Technical Specialist Memo – Contaminated land

Nagaraj Prabhakara, Principal Planner- Auckland Transport

Hunua Quarry Development

FTAA-2603-1185 (Council Reference BUN60464053)

Image 1: Google street view at the bend.

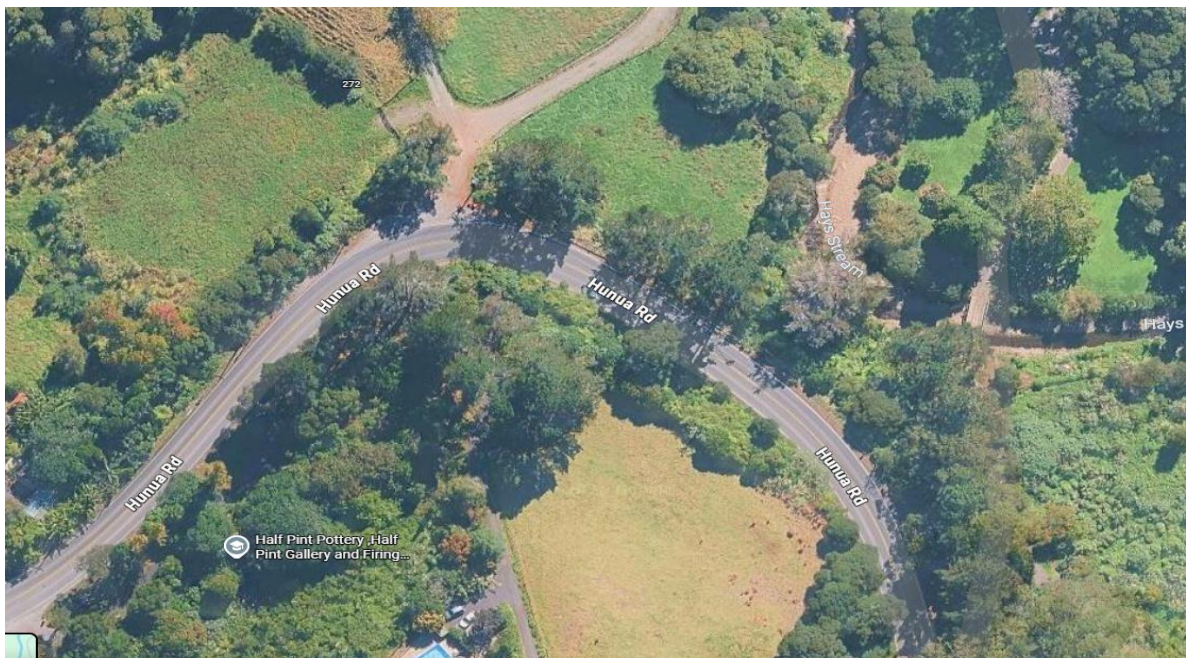
AT's traffic and road safety specialist reviewed the applicant's response, the proposed ATP are considered unlikely to mitigate the safety risks. The mitigation measures should also include improvement to the sightlines between the opposing traffic vehicles at the bend to increase reaction time, reduce centreline encroachment risk, improve safety of heavy vehicle interaction and have a direct reduction in crash likelihood and severity.

Two serious crashes were recorded at the Hunua Road bend in 2023 and 2025, indicating an existing and ongoing safety concern. The horizontal curvature, combined with vegetation and roadside features, restricts sightlines between opposing vehicles. Please refer to image 1.

The proposed additional truck movements associated with the activity are likely to increase safety risks, particularly due to the reduced visibility for oncoming traffic at the bend. Heavy vehicles require greater stopping distances and occupy more lane width, further exacerbating the risk of conflict within this constrained section of road.

The Consent Holder must implement additional road safety mitigation measures on Hunua Road at the horizontal curve located on the western approach to the subject site access, in the vicinity of the recorded serious injury crashes (CAS Crash IDs 2025326299 and 2023273856).

The mitigation measures must include, but are not limited to, **benching or regrading of the cut slope on the inside of the curve** to improve forward visibility and sight distance between opposing drivers. These works must be undertaken in addition to the installation of audio tactile profiled (ATP) centreline markings required by this consent.
